RE: Revised Perc Cert Plan
Nursery View Lots 8 & 9
File No: F-10-87

RE: Plat of Resubdivision Review Comments
Nursery View Lots 8 & 9
File No: F-10-87

RE: F-10-87/Nursery View, Lots 8 and 9, Sec. 3

**RE: File Number: F-10-087
Nursery View Lots 8 & 9 Sec. 3
Old Frederick Rd**

TOPOGRAPHY / SOILS / SWM EXHIBIT
LOTS 8 AND 9, SECTION THREE
NURSERY VIEW
(A REVISION OF LOT 7, SECTION TWO, NURSERY VIEW
PREVIOUSLY RECORDED IN PLAT BOOK 27 AT PAGE 39
AND TAX PARCEL 3)

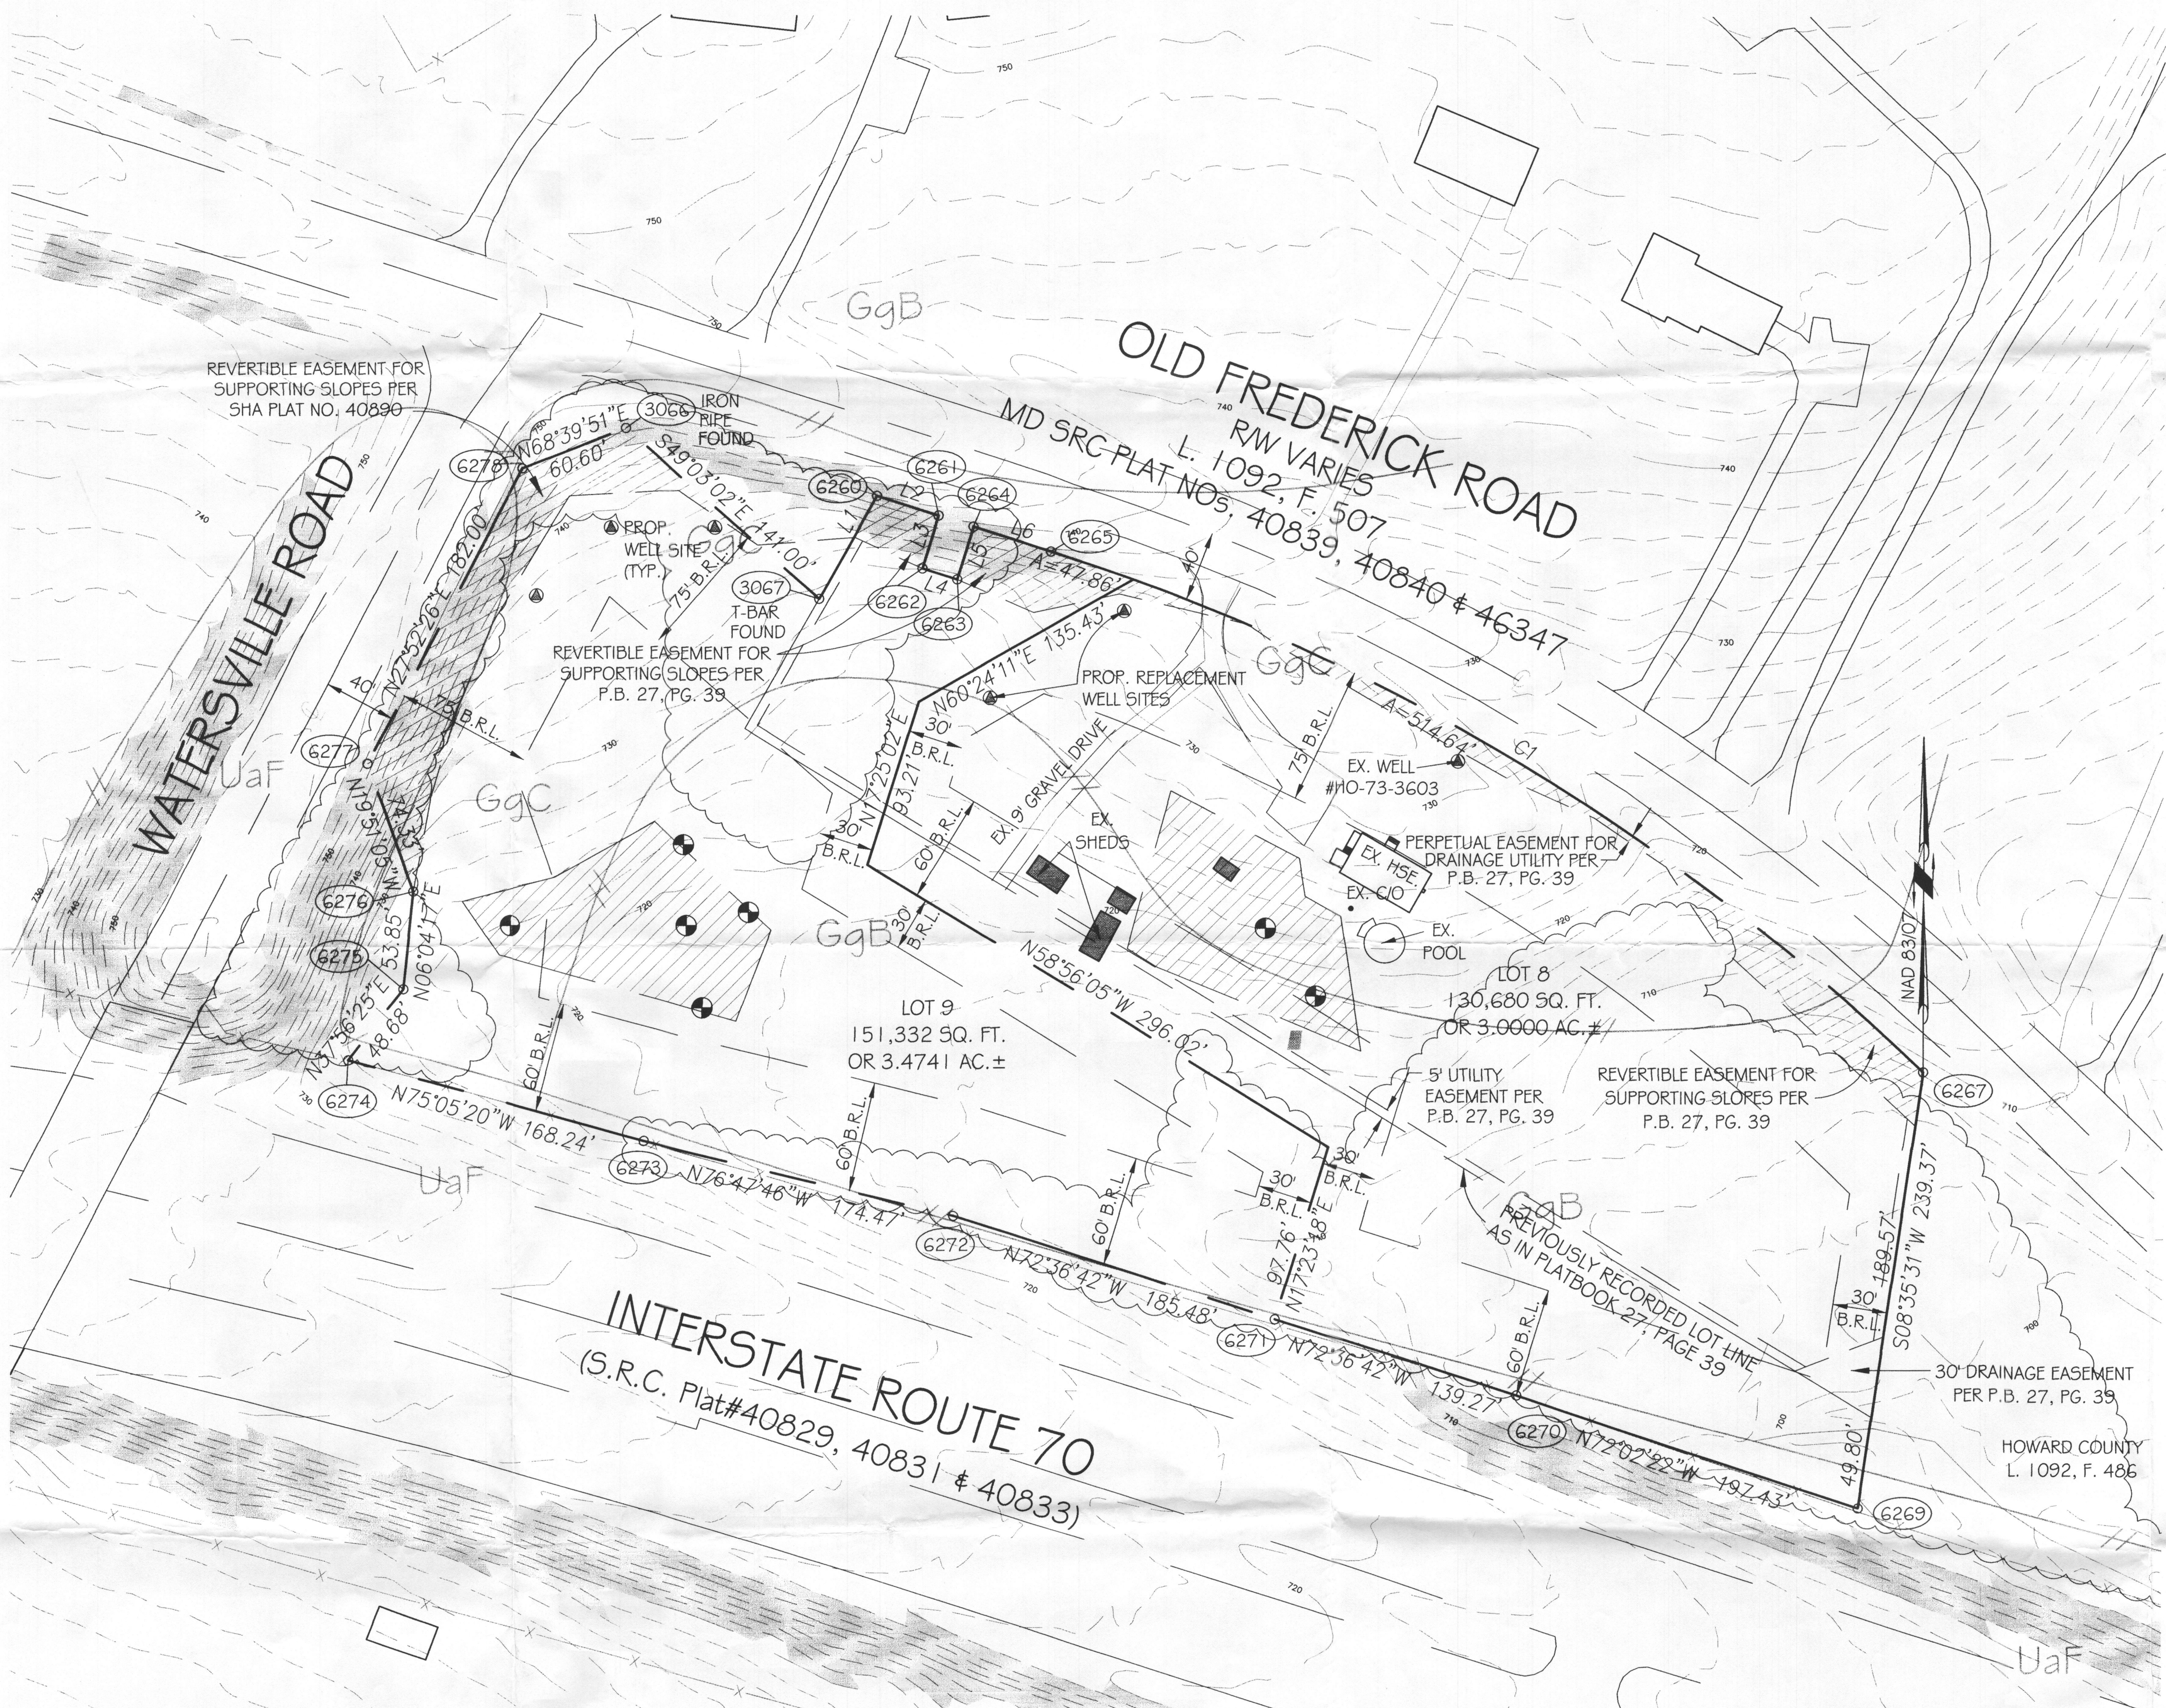
- II.C.1. - On Plat sheet 1 and Topography/Soil/SWM Exhibit, please revise the General Notes to include Noise Study information and provide SWM information based on 2010 SWM regulations that will be enforced from May 4, 2010. Erase the General Note 16 since this plat is not only adjust the common lot lines between former lot 7 and parcel 3 but also change parcel 3 into a buildable lot.

- Unless adequate information is provided, DED cannot verify that proposed Lot 9 (formerly parcel 3) is a buildable lot.
- II.D.2. - On Topography/Soil/SWM Exhibit sheet 1, please provide a minimum of three (3) grid ticks on the plan sheets.

- III.A.2. - On Plat sheet 1 and Topography/Soil/SWM Exhibit, please show the adjacent right-of-ways, street names, street classifications, Existing and proposed R/W width.

- IV.A.1. - On Plat sheet 1 and Topography/Soil/SWM Exhibit, please check right-of-way dedication with the current Howard County General Plan of Highways and approved construction drawings. Provide right-of-way dedication language if it is applicable.

- IV.A.5. - On Plat sheet 1 and Topography/Soil/SWM Exhibit, please include access restriction
